ADDENDUM NO. 2

Agency Name: DMHMRSAS
Project Title: Southside VA Training Center Building 111
Roof Replacement
DMHMRSAS Project Code: 720-17227-26-01
DGS Project Code: 720-06720-018
IFB No. 07-10

Attachment: SK-3 (Revision 1 to Section 6 on Drawing A4 dated 15 Jun 07)

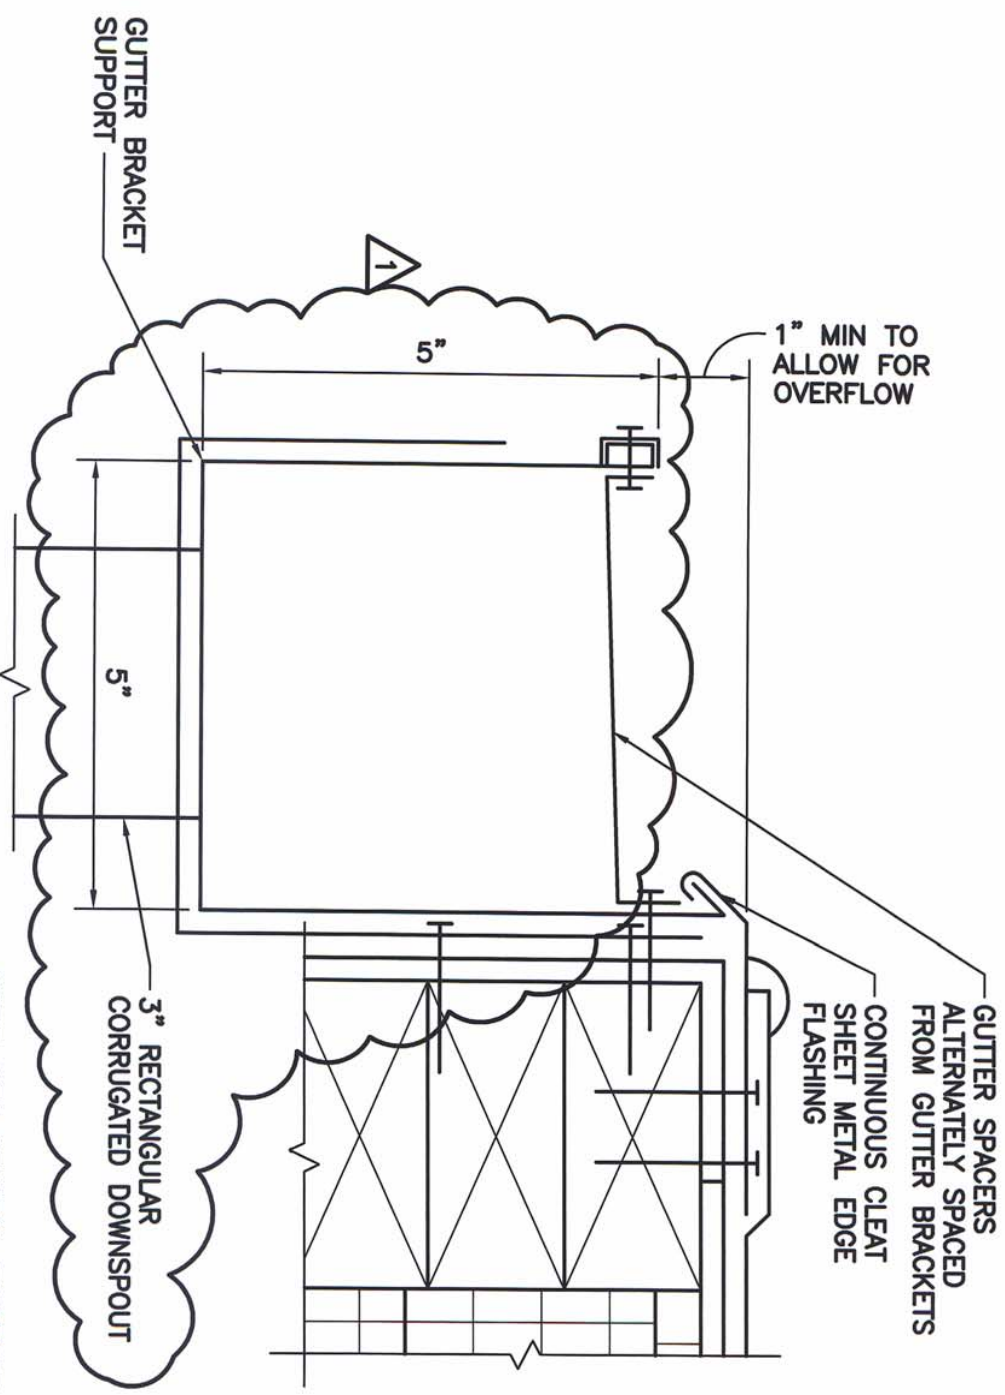
3. The FRT plywood shown in Section 2 on Drawing A4 shall extend to the underside of the existing stone coping.
4. See attached revision to Section 6 on Drawing A4 for change in gutter and downspout sizes.

SECTION - TYPICAL GUTTER
